WinProLadderV2.36 Change Note

1. ROM_PACK operation screen

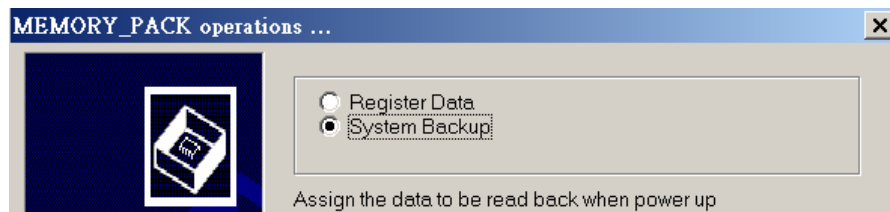
Original V2.35

New V2.36

ROM_PACK operation screen will be displayed

If the PLC_OS is below V4.46

If the PLC_OS is V4.46 or after
